**SUMMARY OF CHANGES  
ITS SECTION 3.4**

**Attachment 1, Volume 9, Rev. 1, Page ii of vii**

Figure 3.4.3-1

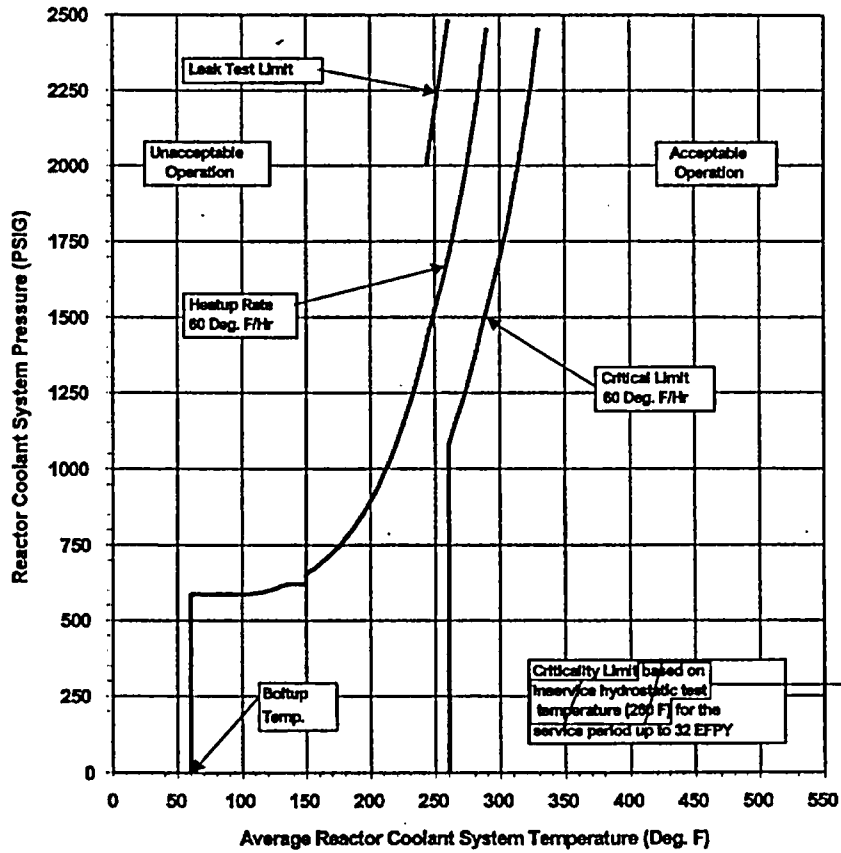
- L.2 (Category 1 – Relaxation of LCO Requirements) CTS Figures 3.4-2 and 3.4-3 describe in the Header that the P/T curves are generated without margins for instrument error, and describe the limiting material, initial ART value, and the limiting ART value that are used to determine the P/T limits. CTS Figure 3.4-2 also states (in the figure portion) that the criticality limit is based on inservice hydrostatic test temperature of 259°F (Unit 1) and 260°F (Unit 2). The ITS Figures 3.4.3-1 and 3.4.3-2 do not include this information. This changes the CTS by deleting this information from the CTS.

The purpose of this information is to provide additional detail as to how the P/T curves were generated. However, deleting this information is acceptable because it is not necessary to be listed in the Figures in order to properly use the Figures. ITS 3.4.3 requires the Figure limits to be met. The details as to how the Figures are generated is not needed to comply with the LCO. The ITS 3.4.3 Bases describes that the Figures were generated to comply with the applicable regulatory requirements of 10 CFR 50, Appendix G and ASME Section III, Appendix G. Therefore, since CNP is required to comply with 10 CFR 50, Appendix G and ASME Section III, Appendix G, this additional information is not required. This change is designated as less restrictive because certain details related to how the LCO was generated are being deleted.

Figure 3.4.3-2

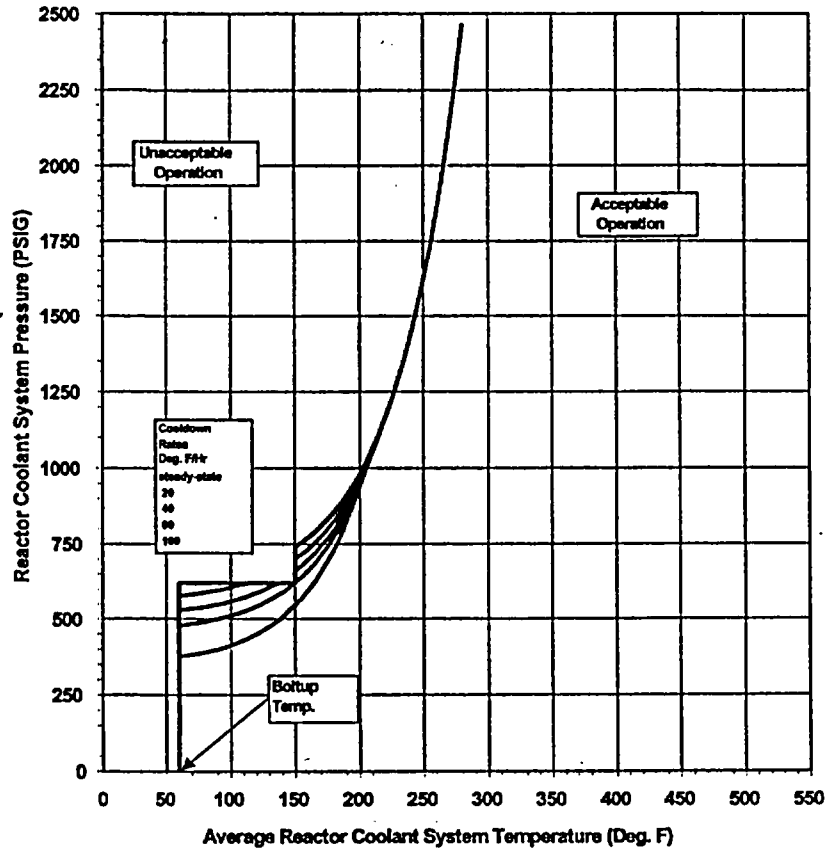
Reactor Coolant System Cooldown Limitations ~~Without Margins for Instrumentation Error~~  
 Applicable for 32 EFPY of Operation  
 Limiting Material: Intermediate SRR Plate C5358-2, Cu = 0.13%, Ni = 0.57%  
 Initial ART: 58 Deg.F, Limiting ART Values at 32 EFPY: 1/4T = 200 Deg. F, 3/4T = 169 Deg. F
